**Final Drainage Report Addendum
Peaceful Ridge at Fountain Valley Subdivision
El Paso County, Colorado**

May 2023

PCD File No. CDR-22-015

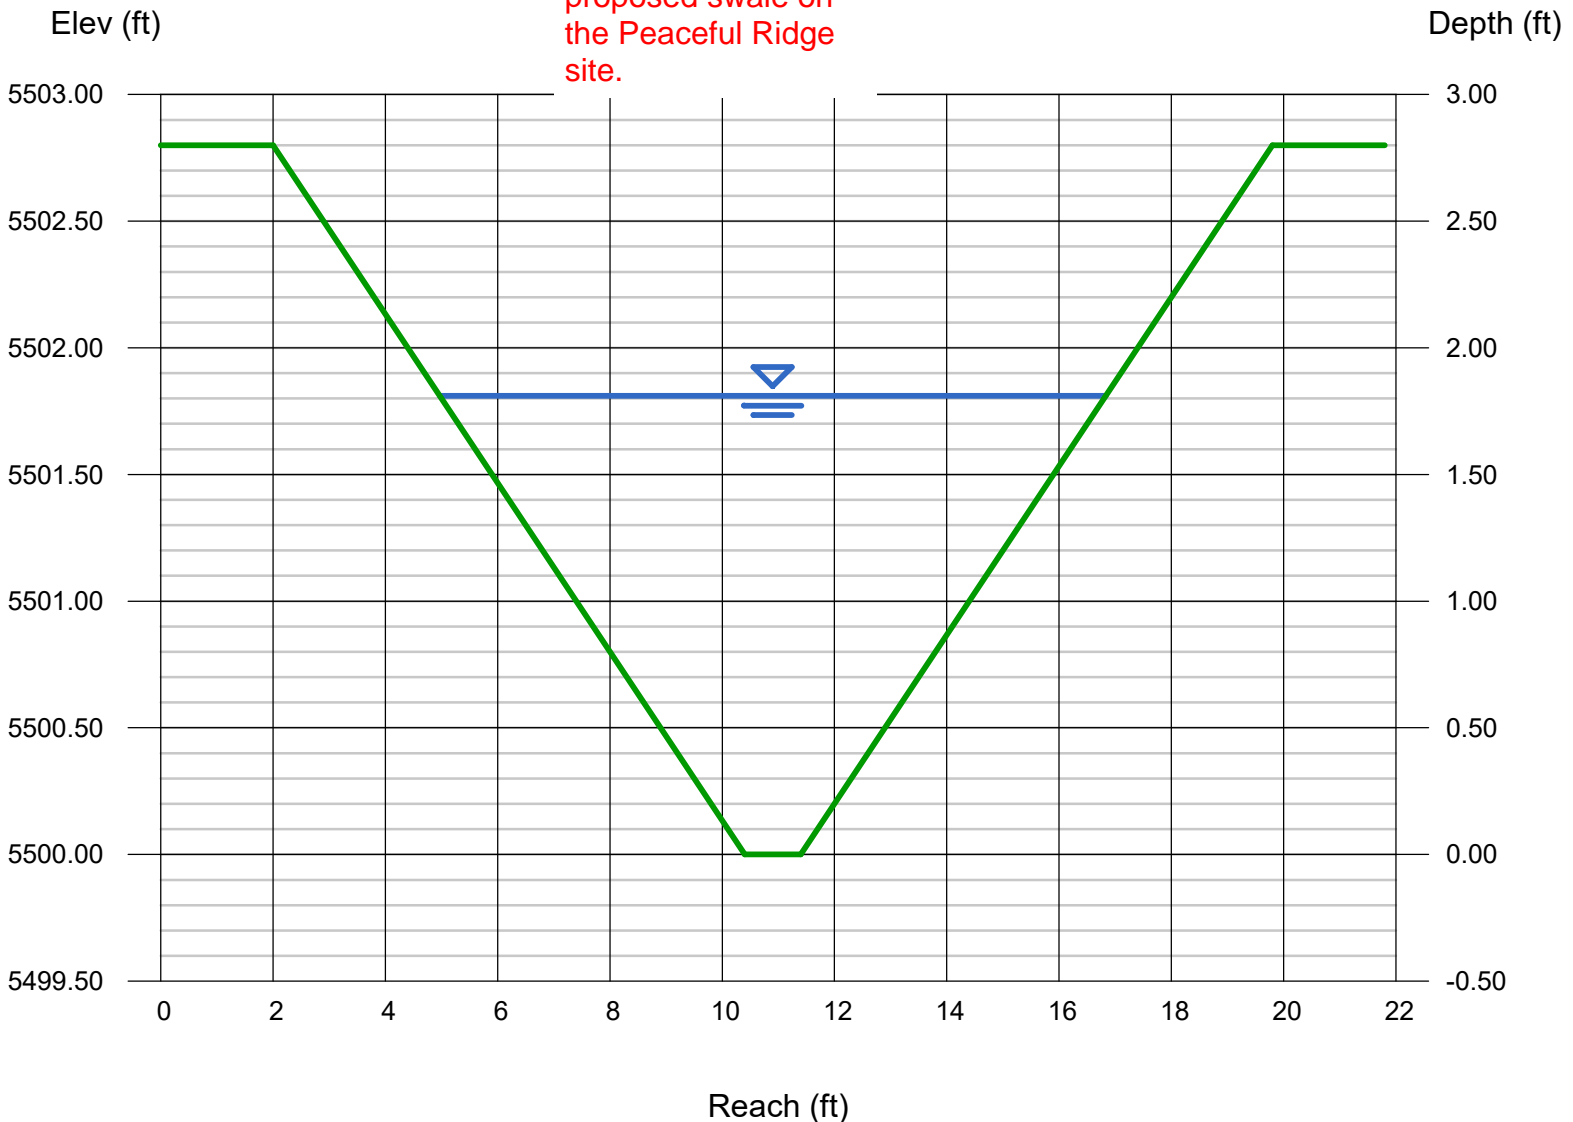
It appears this flow is only accounting for this subdivision's contribution to the channel. Revise to include Cottonwood Meadows' flows that drainage to this channel.

Revised. Off-ste area from Cottonwood Meadows has been added to a new proposed swale on the Peaceful Ridge site.

DETENTION BASIN STAGE-STORAGE TABLE BUILDER

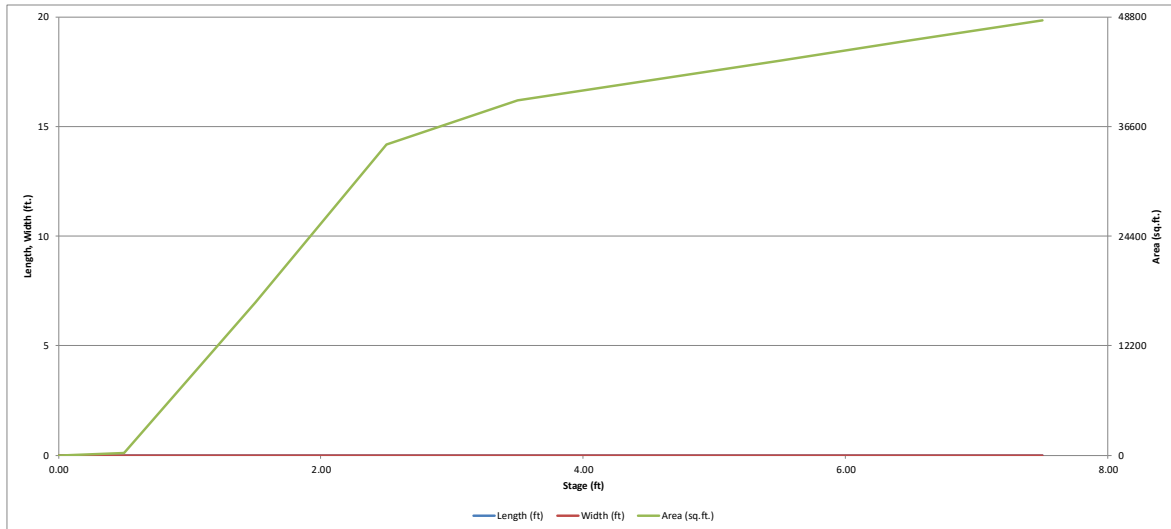
Unresolved from review 1. It does not appear that this sheet has been updated to match what was approved. Discuss in a narrative what changes are being proposed and why. It appears a smaller pond would be needed with these calculations.

SHEET DRN 01

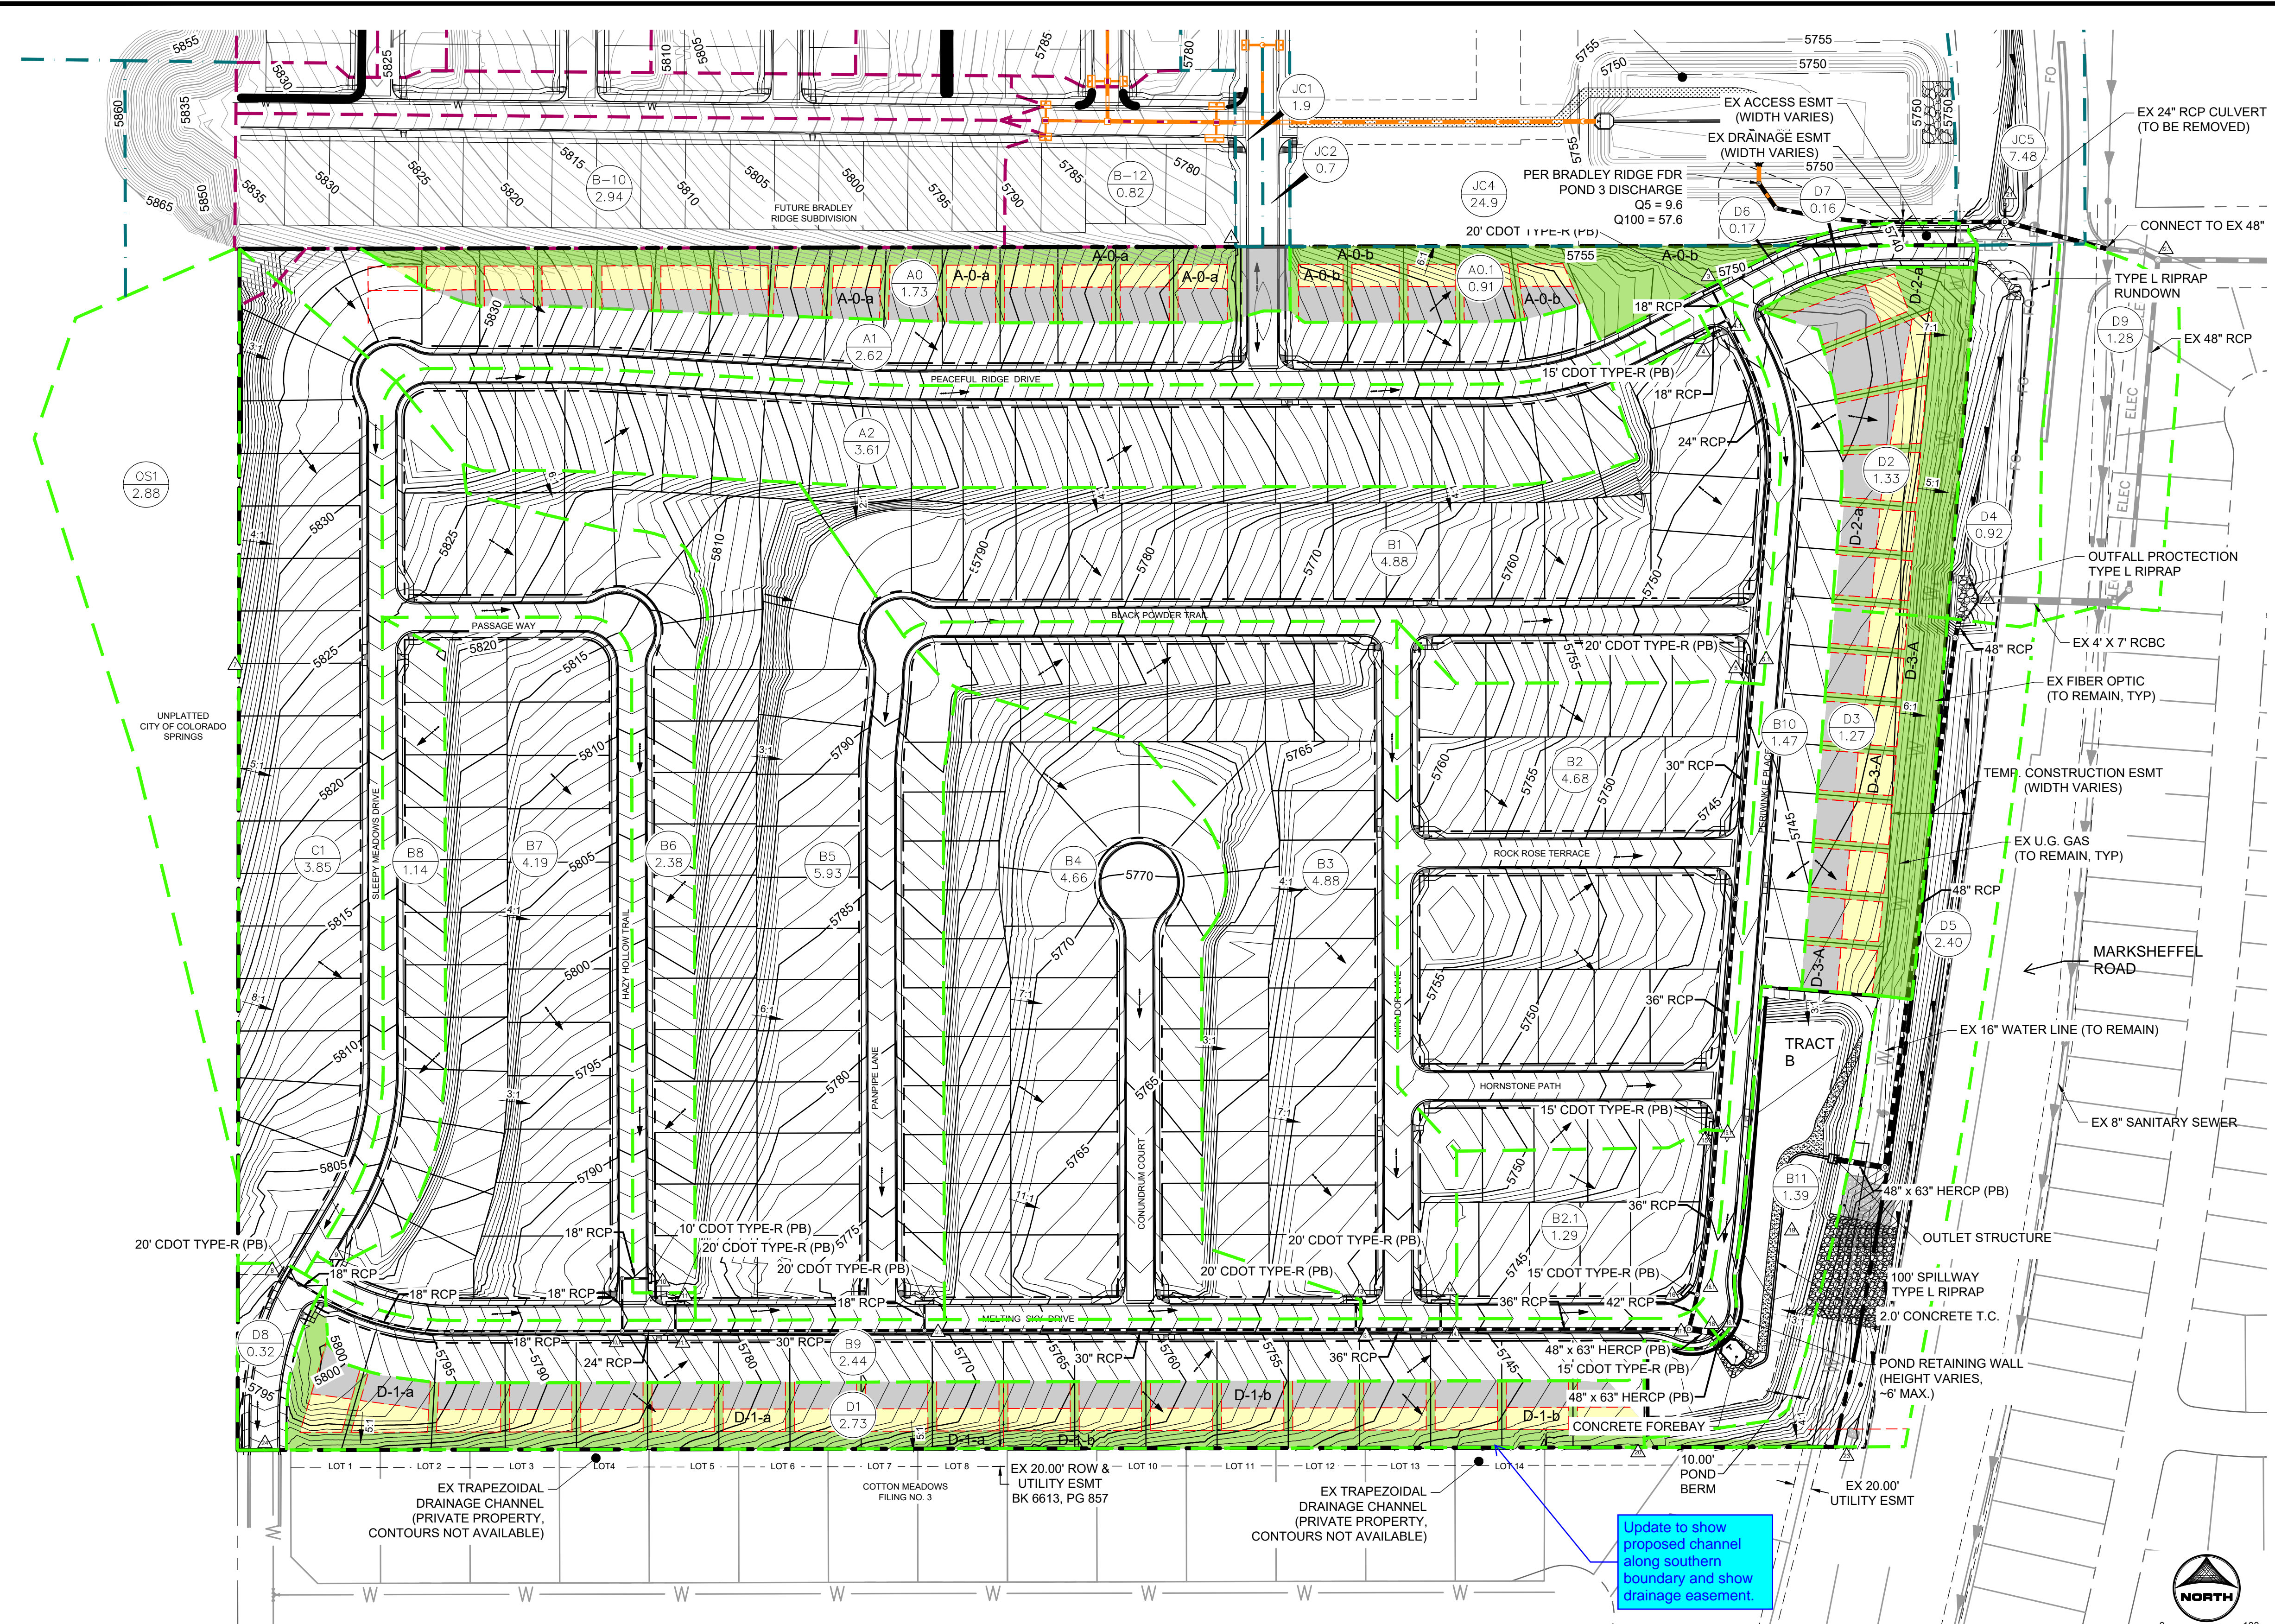
Update to show proposed channel along southern boundary and show drainage easement.

Revised. This has been updated to show proposed contours along the southern boundary and the proposed 20' drainage easement.
